Model : GP605

Ref. No. : FF-T01-K1-000011-UK3

Location : ADF REVERSING FLAPPER

Subject : MEASURES TO PREVENT THE ADF REVERSING FLAPPER FROM STAYING OPEN

Fig. 1

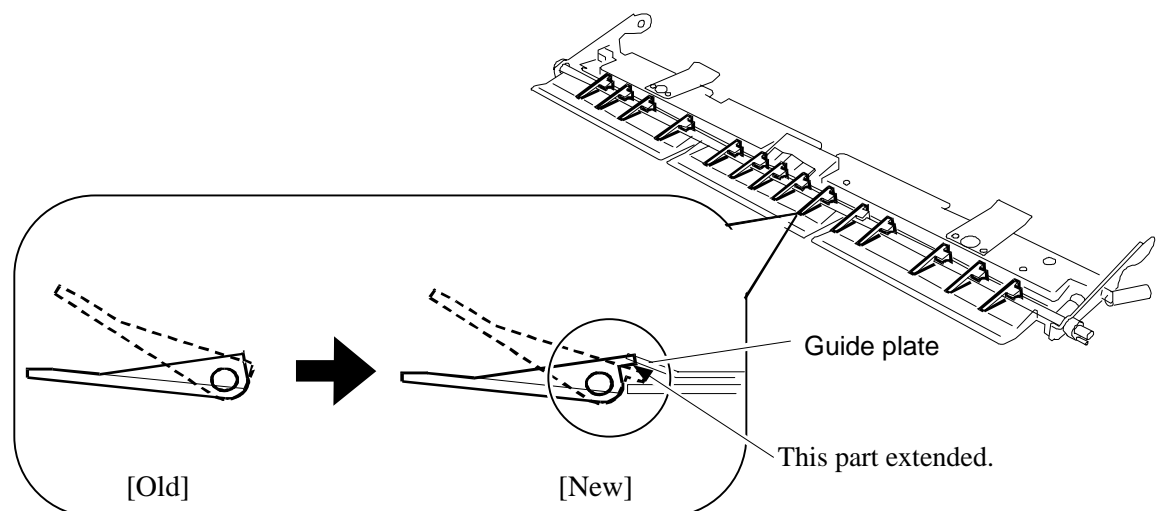
Details : <Symptom>
The user in the course of clearing a jam in the ADF tries to manually open the flapper at the lower part of the ADF, and finds oneself that the flapper stays open.

<Cause>
In the course of clearing a jam at the lower part of the ADF, the lower guide cover indicates that it should be opened with the hands, but depending on how the user opens it, the flapper stays open.

<Factory measure>
The reversing flapper has been extended with a change in the shape to prevent overriding the guide plate. (Fig. 1)

Fig. 11

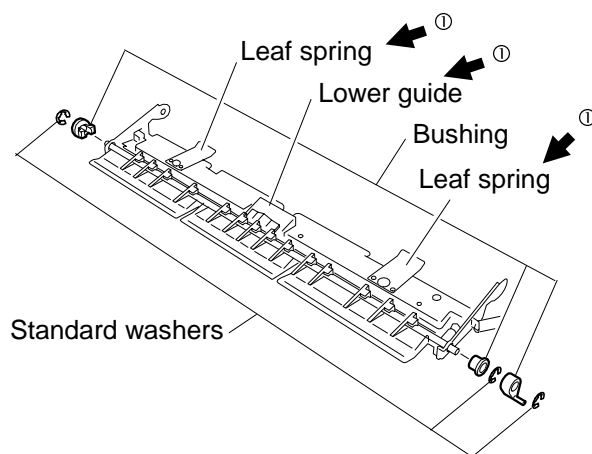
- 10) Remove the 3 standard washers from their locations and remove the shaft.
 11) Replace the reversing flapper with its countermeasure replacement, and re-attach the bushing and the standard washers. (Fig. 11)

If it is noted that the flapper stays open, replace also the lower guide at the same time.

* When replacing the lower guide, be sure to use the leaf spring while repalcing the guide with a new one.
